H12125

DESCRIPTIVE REPORT

Descriptive Report to Accompany Hydrographic Survey H12125

Revisions Compiled During Office Processing and Certification

Figure 7. North-East Edge of Survey Area

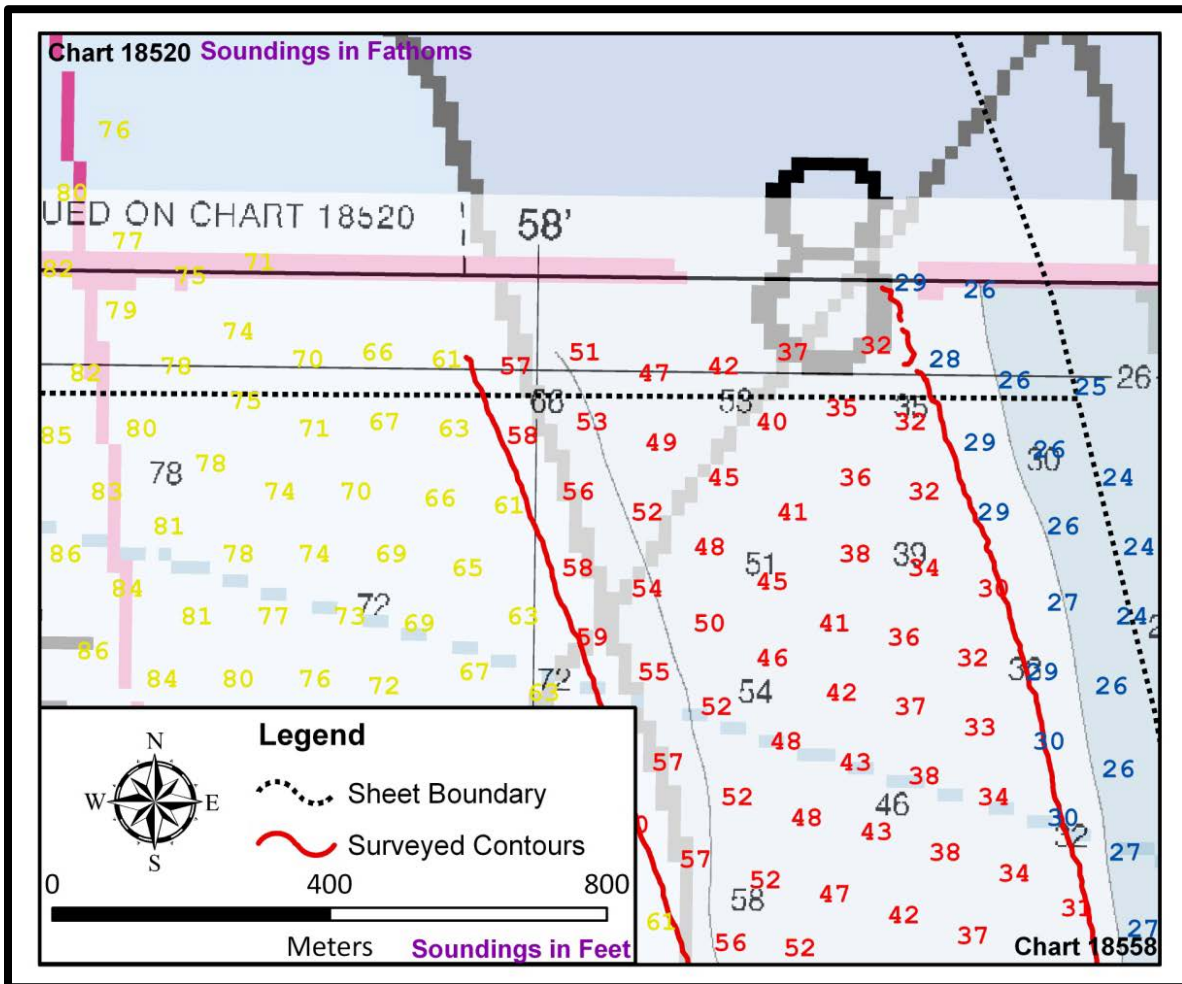
There is shoaling of over 3 fathoms centered near the charted 8 fathom sounding at the northeast corner of the survey area when compared to chart 18520 and the ENC (Figure 7). When compared with chart 18556, there is 5 to 10 feet of shoaling in the same area, a westward movement of the 30-foot contour approximately 100 meters (5mm at chart scale), and a westward movement of the 60-foot contour approximately 150 meters (7.5mm at chart scale).²³

²³ Concur. Chart depths as depicted in the HCell and update charted contours based on the survey data.

Figure 1.1.1

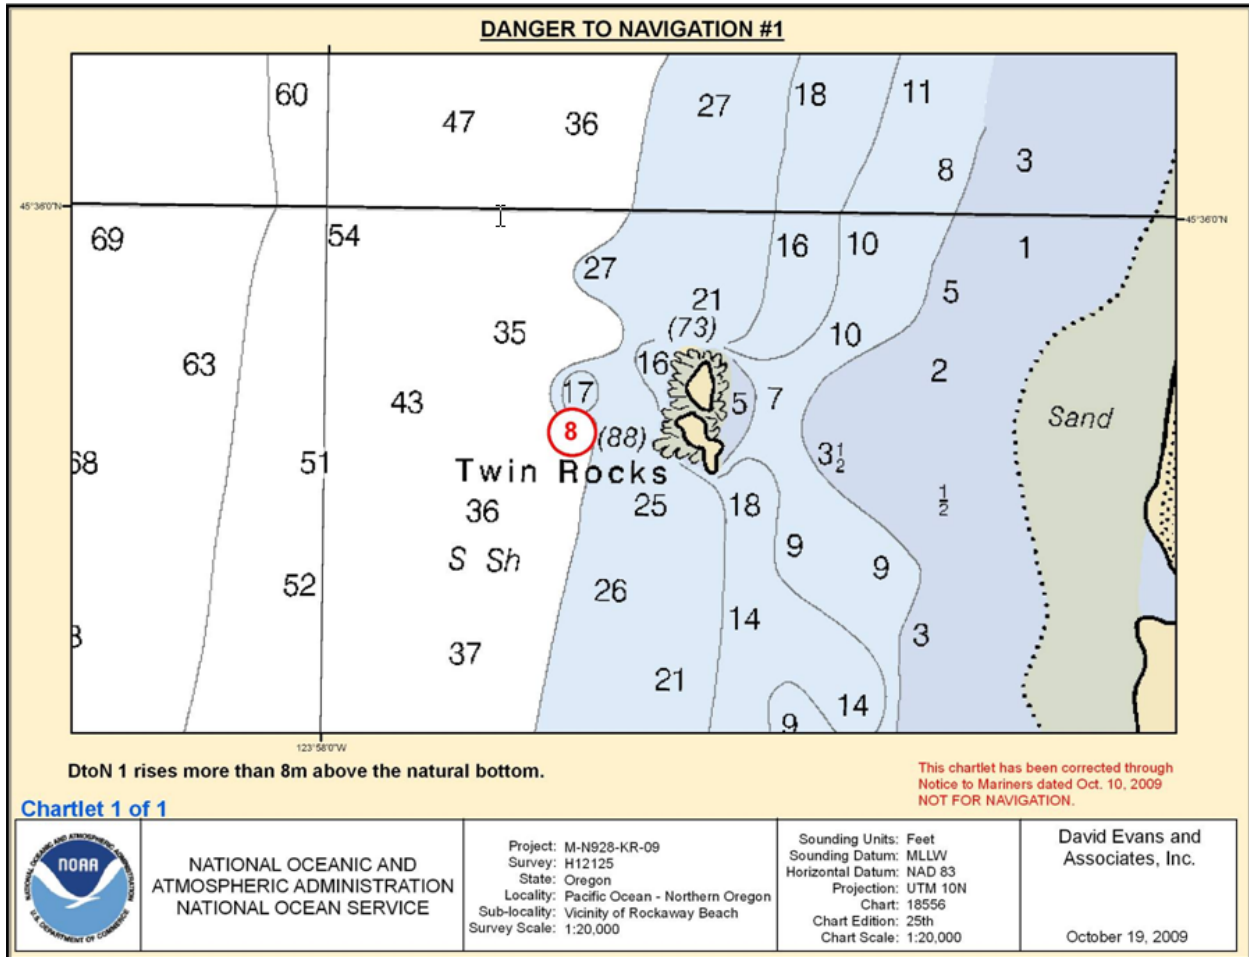
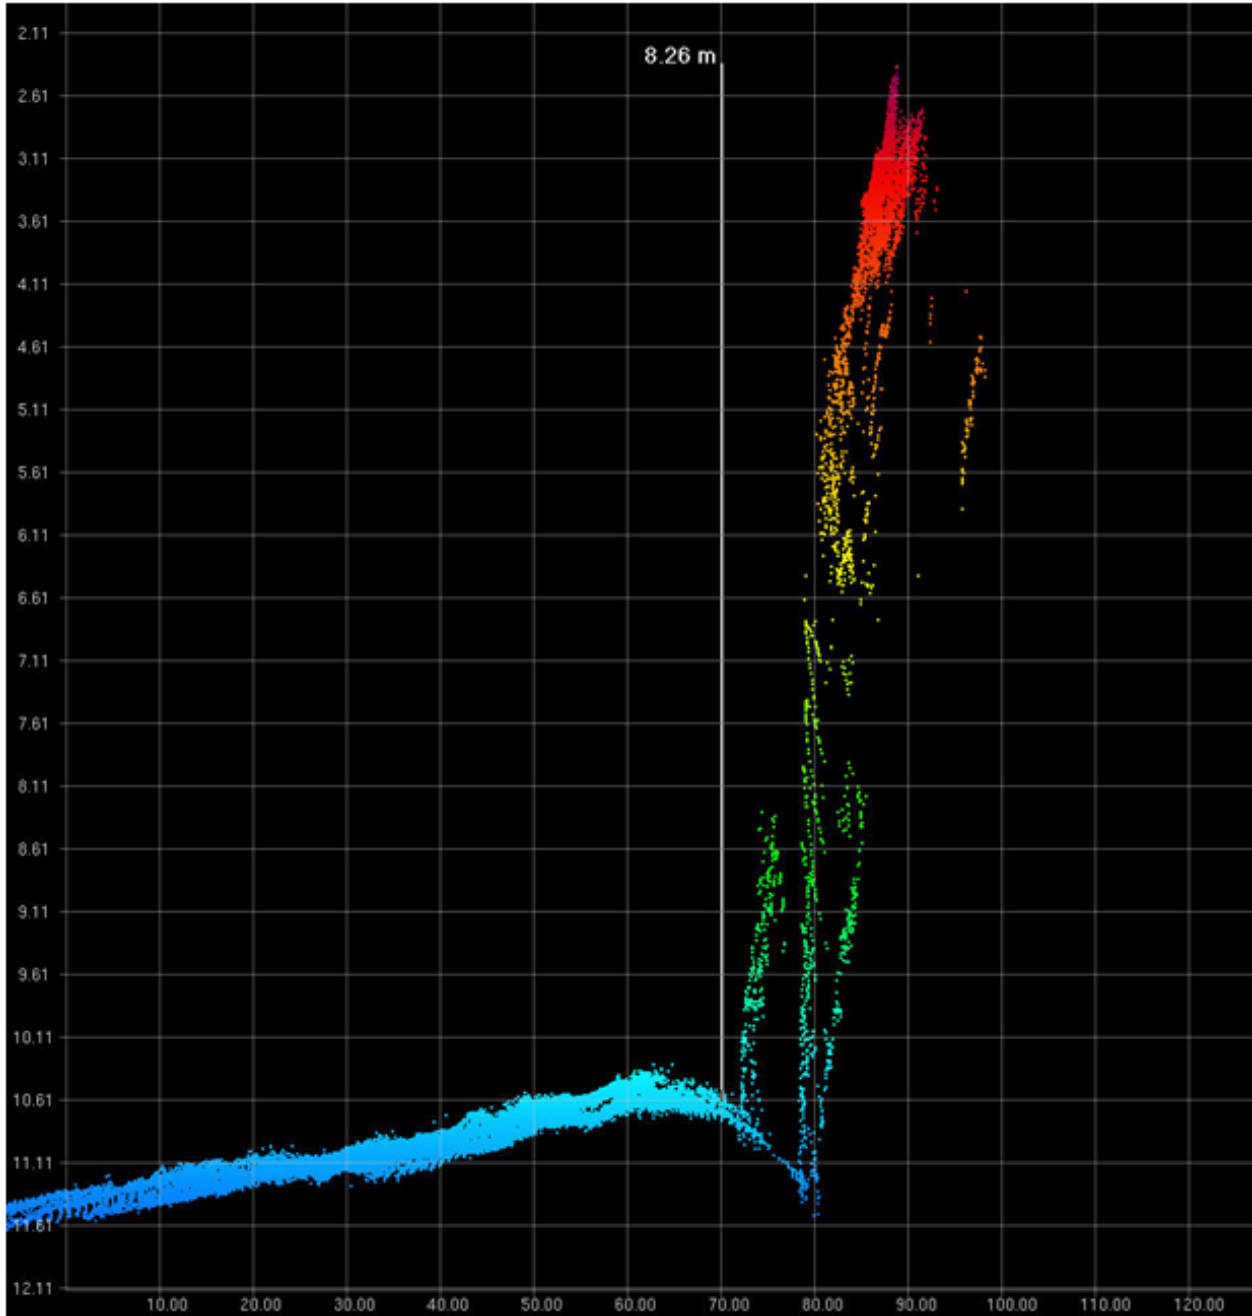
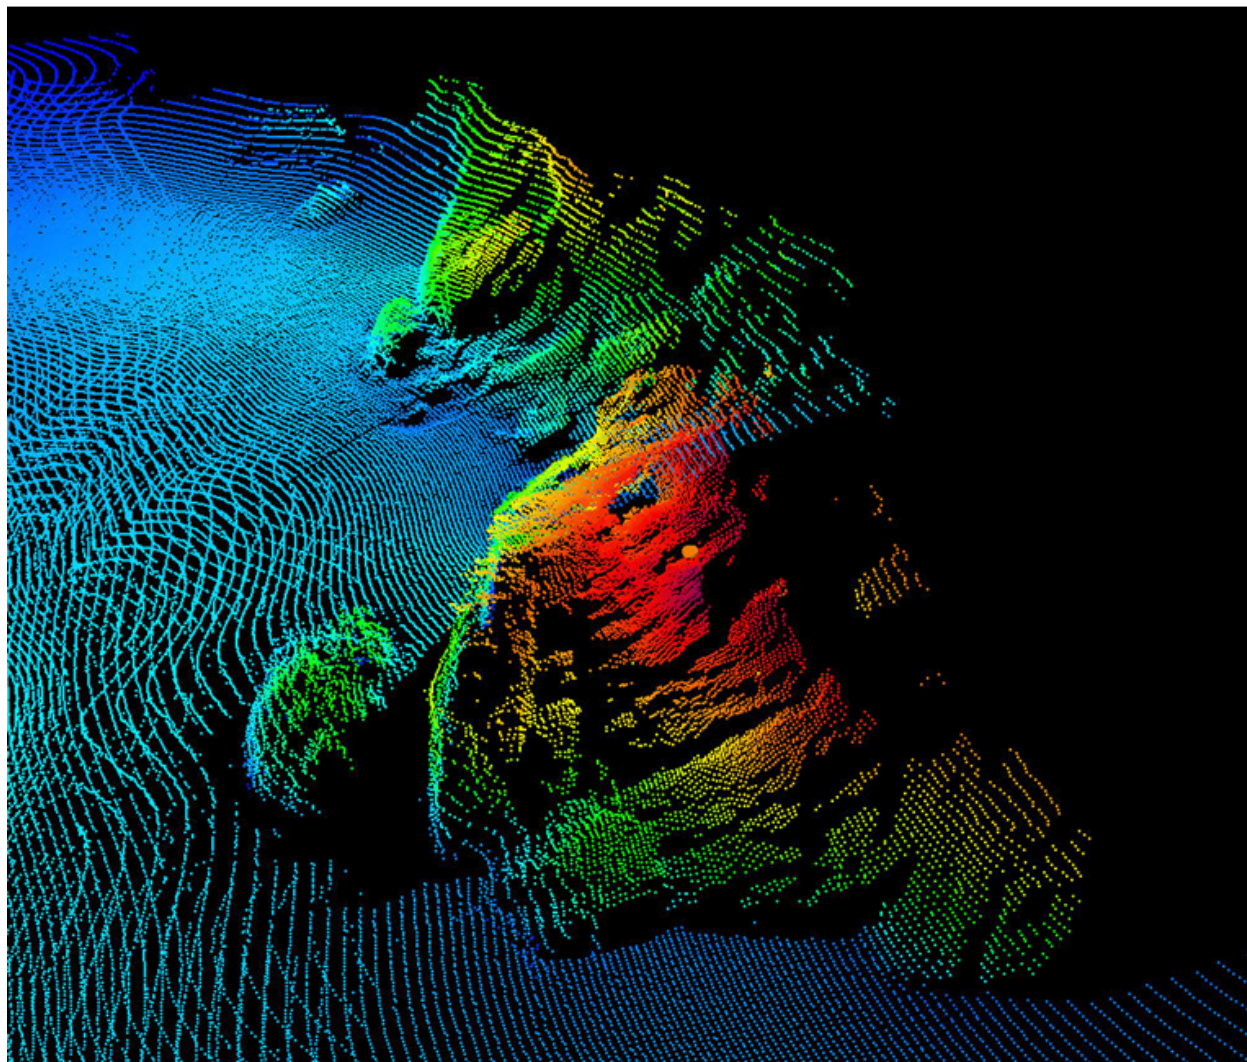
DtoN 1 is a rock approximately 125m due west of Twin Rocks. The true least depth and dimensions of this feature is unknown due to it being too shallow to survey safely.

Chart as a dangerous underwater rock of uncertain depth.

²⁹ Concur with clarification. The correct least depth for DTON#1 is included in the HCell. DTON#2 has also been included in the HCell. Chart both per H12125_CS.000
